EXHIBIT "A" Concrete Repair Cost Proposal Form for Fredrick Douglass Gym

EXHIBIT "B" Repair Details SK 1 – 10

Frederick Douglas Gym
Structural Repairs
McCarthy Project No. M13178

EXHIBIT "C" Field Notes from Site Visits April 26 & 27, 2017

Douglass Hes schmary table SUBJECT

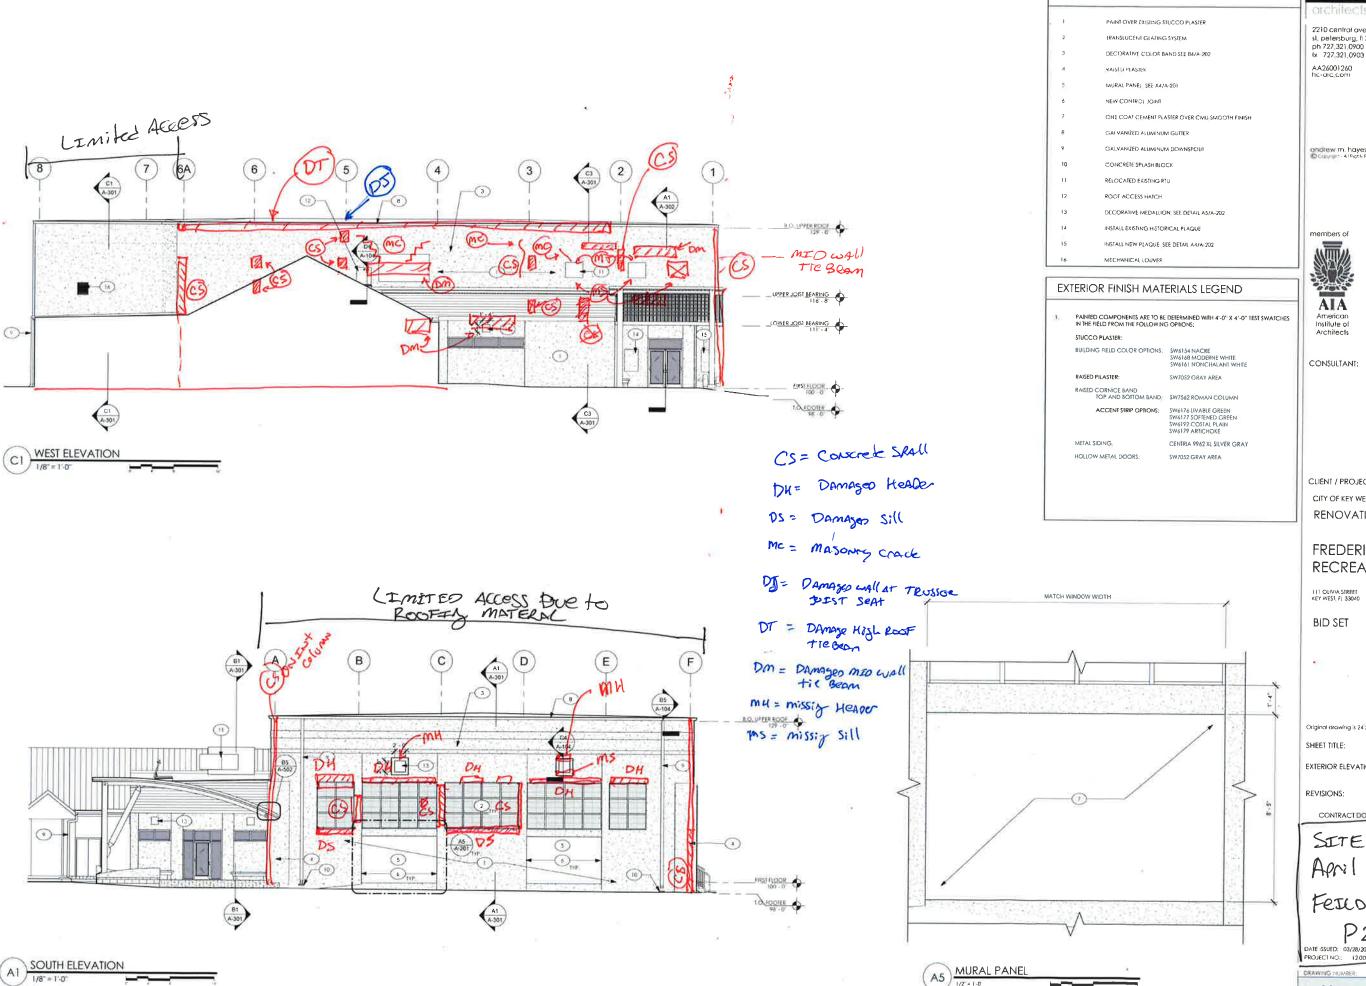
MACK	DAMAGE LEGEND	Denta Omi	
CS	DESCRIPTION CONCRETE SPALL AT COLUMN OR MISCLEANOUS LOCATION INCLUDING CETLINGS	SK: 4-6	
DH	DAMAGEO WINDOW HEADER	SK: 4-6	
DS	Dampgeo wixxxx STEL	Sk -3	9
MC	Masoney Ceack	-N/A	
D2	DAMAGED JOIST SEAT	SK-2#10	
DT	DAMAGED TOP OF WALL TIE BEAM	SŁ-I	
Dm	DAMAGEO MED WALL TIE SEAM	Sk: 4-6	
MH	Massing Meader	N/A	
MD+ SD	MISCHENOUS COSMETIC DAMAGE to Stucco NOT. INCLUSED IN SURVEY	N/A	
MI	MASONRY INFILL WALL NOT TIED IN to SURRUNDING WALL	Sk-9	
CC	CONCRETE CRACK	Sk-7	
MH + MS	MISSING HEADER & SILL AT OPENING to BO. INTILLED	X SEE ORG PLOUS DETAIL 2/5-302	PI

A-201

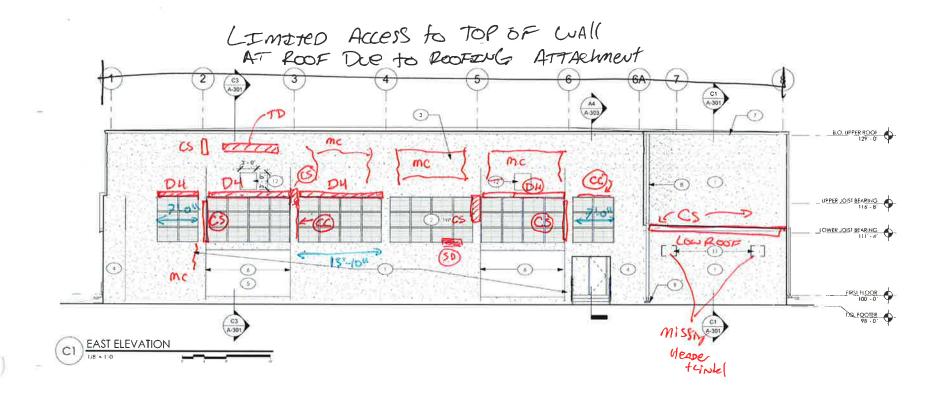
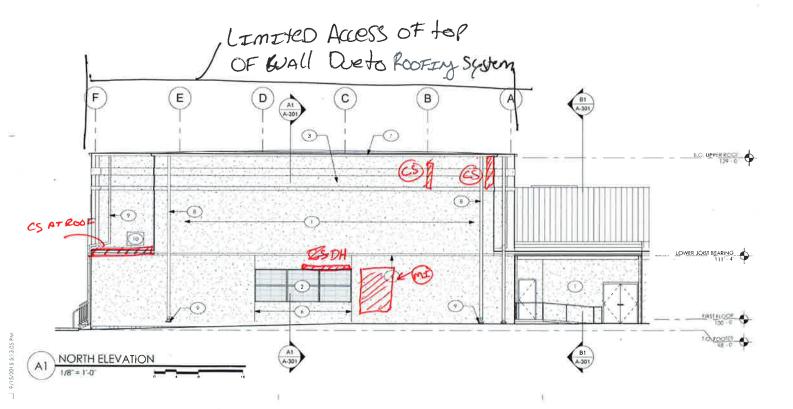
SITE VISIT April 26-27,2017

FEILD NOTES

A-202

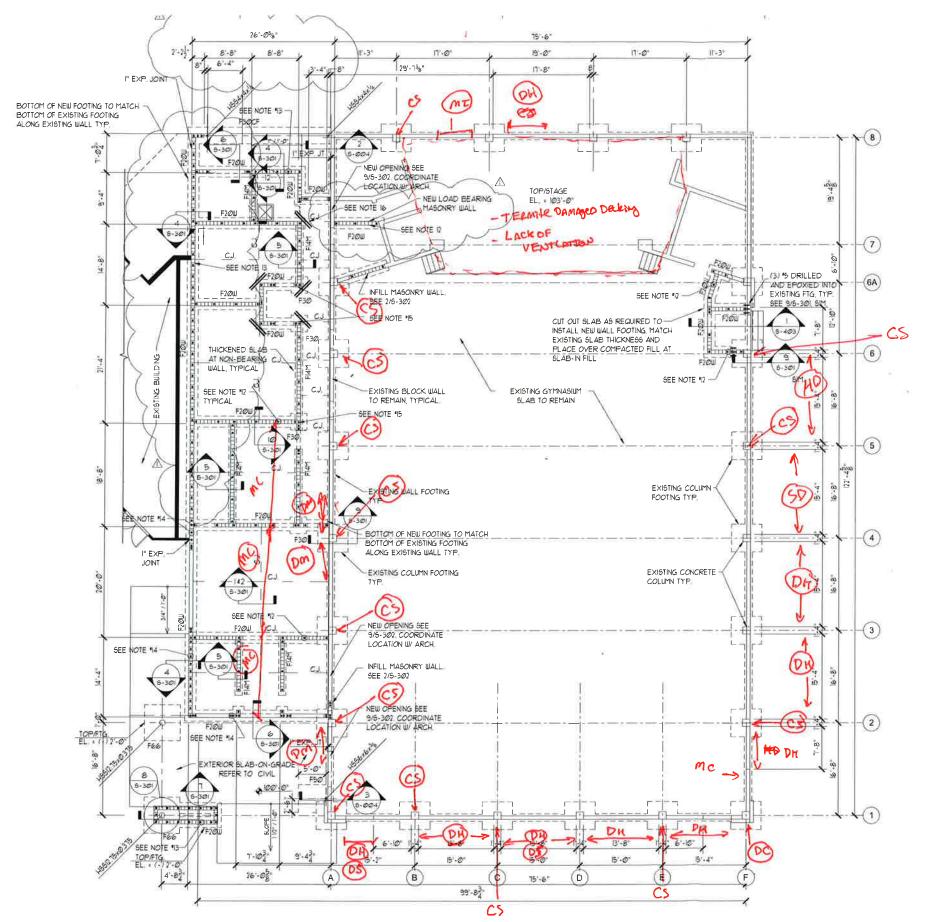
SITE VISIT FETLD NOTES

-101 SHEET: 5 OF 14

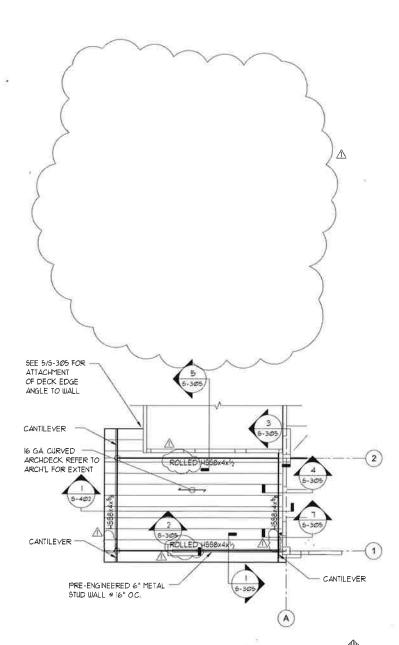
Cosnetic Damags

MD = MISCLEANOUS DAMAGE to INFILL
MASONY & STUCCO DAMAGE IS
NOT Shown FOR CLARITY

AMC = Found to Be AN ISOCATED
COCATIONS AND APPEARS to
Be REPLECTED through
Stucco cracky. this
Damage IS Cosmetic

FEILD NOTES

SHEET: 6 OF 14

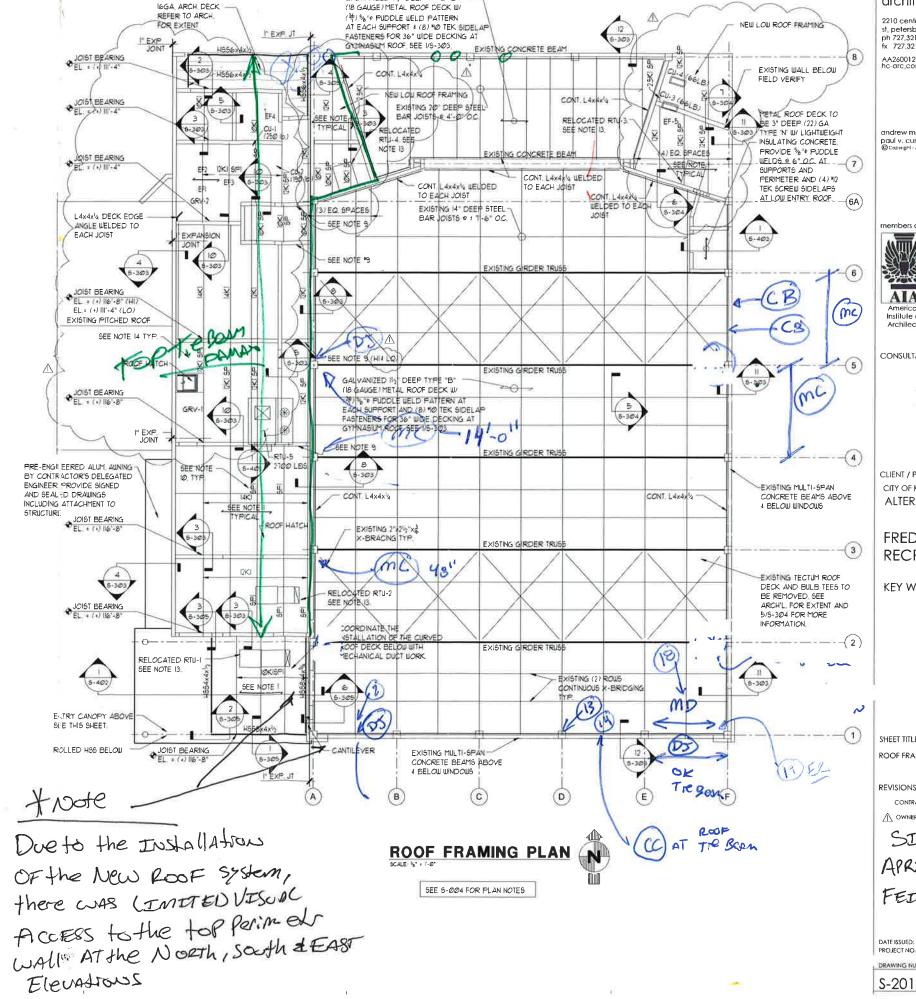
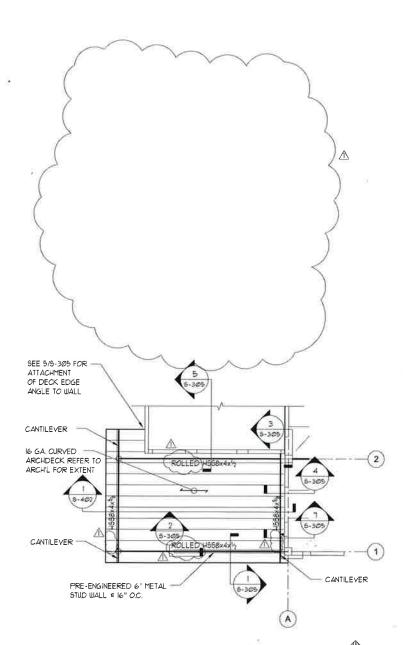
SITE VISIT APRIL 26-27,2017

FELLDNOTES

S-201 SHEET: 6 OF 14

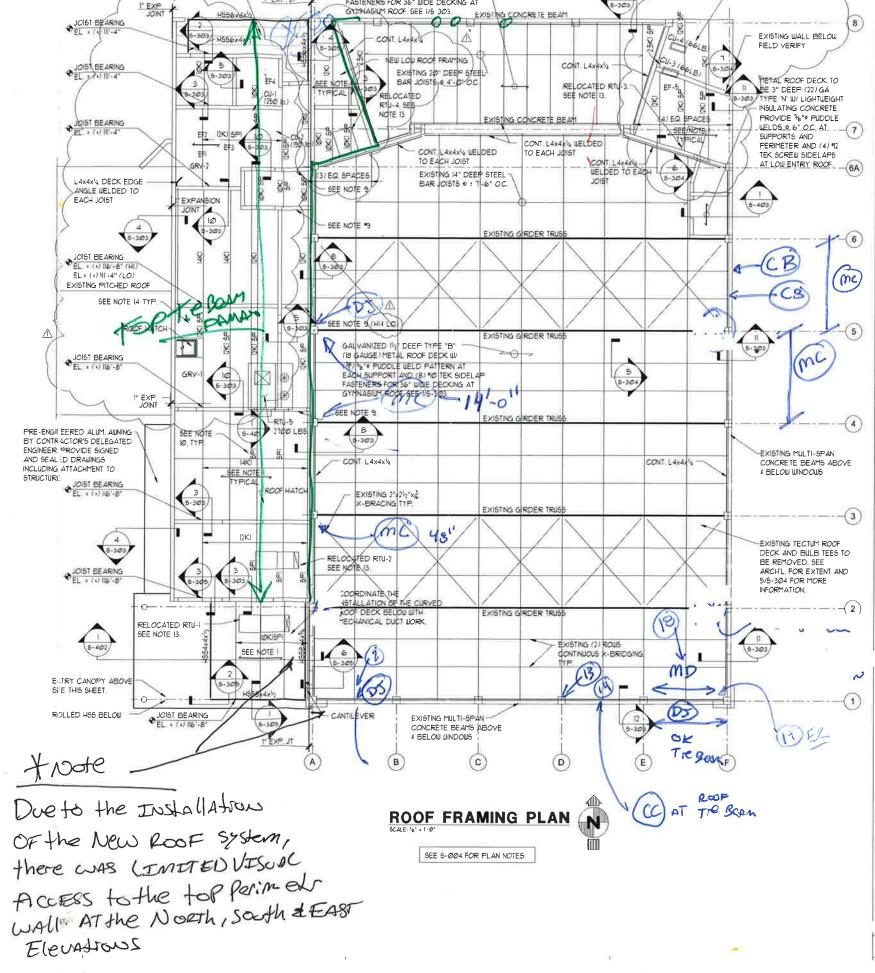
APRIL 26-27,2017 FELLONOTES
